STAFF DESIGN COMMISSION REPORT RE-REVIEW

Project Name: Trio/BP Auto Service Station – Sign Variation
Project Address: 2250 S. Arlington Heights Road
Prepared By: Steve Hautzinger

DC Number: 21-053
Petitioner Name: Heidi Lapin
Petitioner Address: WT Group
2675 Pratum Avenue
Hoffmann Estates, IL 60192
Meeting Date: August 24, 2021
Re-Review Meeting Date: September 28, 2021

Aerial of Property

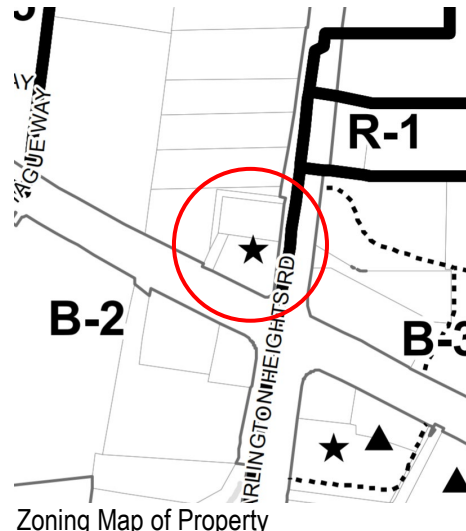
The petitioner is proposing a façade renovation and new signage to rebrand the existing Maverick/BP automotive service station to a Trio/BP service station. The new signage includes replacement of one ground sign, two wall signs, two point of purchase "POP" wall signs, one car wash canopy sign, and the addition of a fourth BP logo to the fuel pumps canopy.
